Re: SPR2601-01: Dennington-Helgren New Single Detached Dwelling Unit, Detached Accessory Dwelling Unit, and Site Improvements, Final Plan Review & Public Hearing

Re: SPR2601-01: Dennington-Helgren New Single Detached Dwelling Unit, Detached Accessory Dwelling Unit, and Site Improvements, Final Plan Review & Public Hearing

Re: Project File SPR2601-01
Project Name: Dennington-Helgren New Single Detached Dwelling

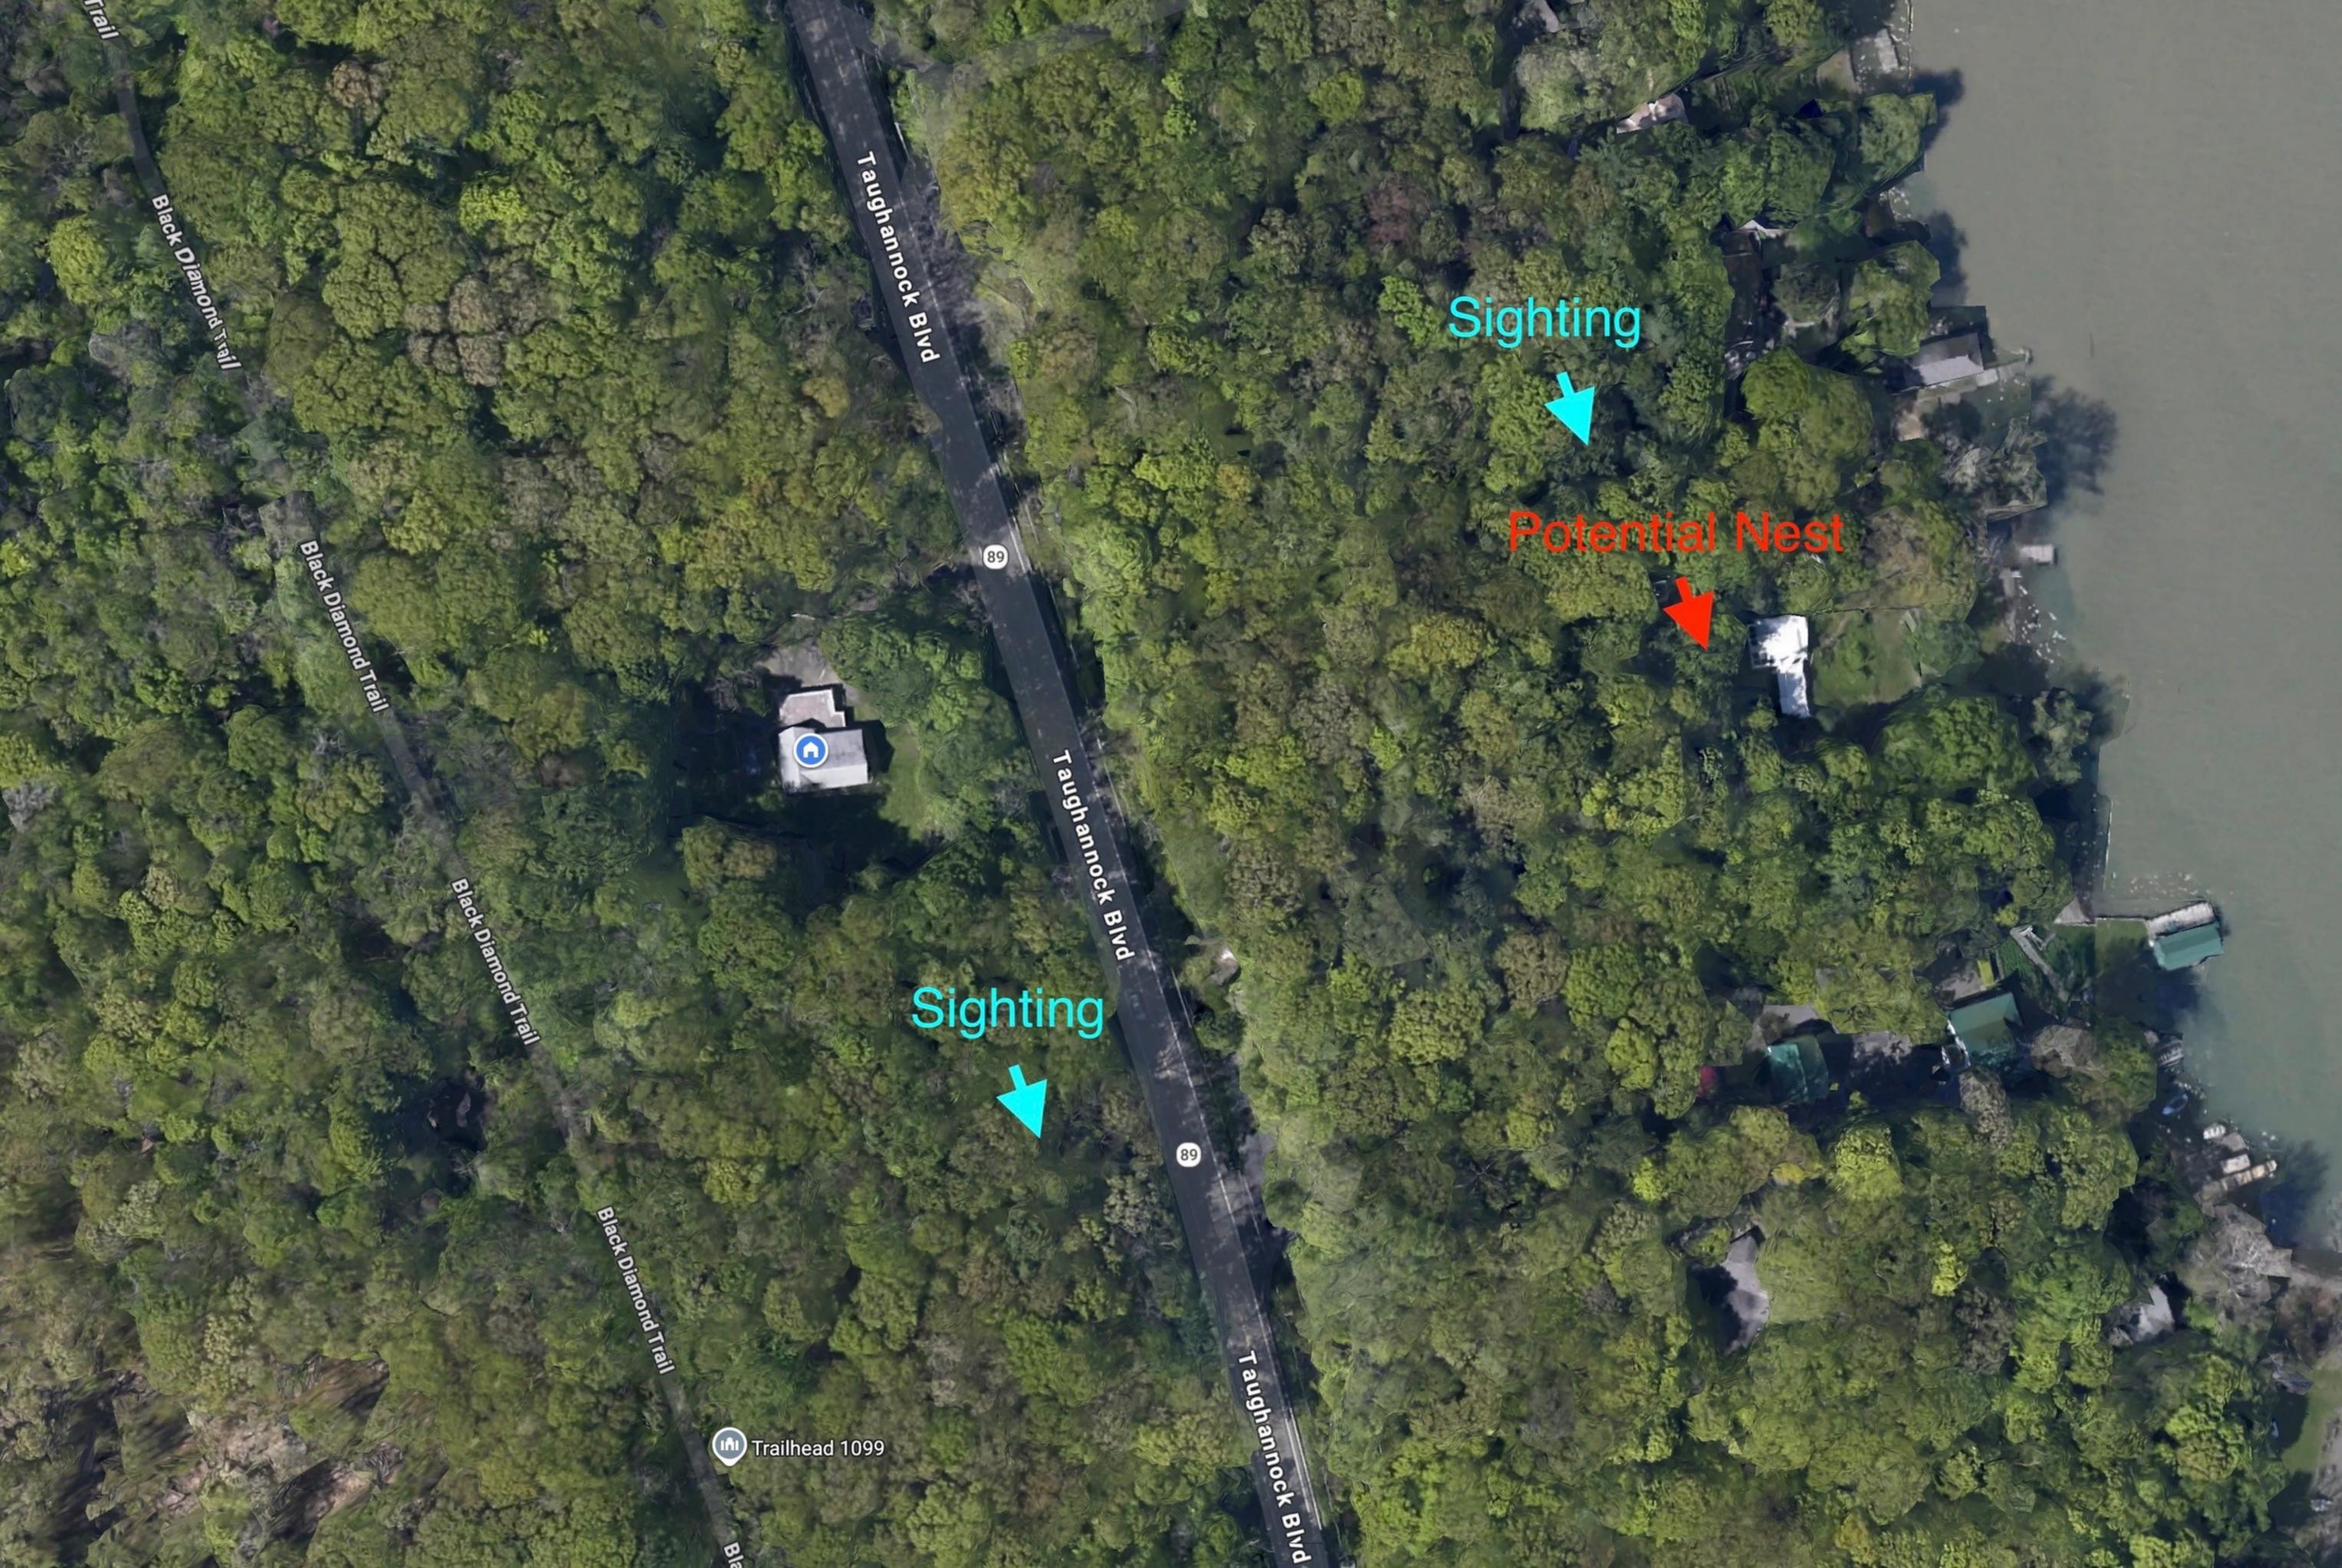
Finally, there is evidence of a bald eagle nest under 660ft from the project area. I ask the Board to determine whether further investigation is needed regarding the presence and status of the nest, potential construction impacts during the breeding season, and whether consultation with NYSDEC or the U.S. Fish and Wildlife Service is required before any approval or site disturbance.

Sighting

Potential Nest

Sighting

Trailhead 1099
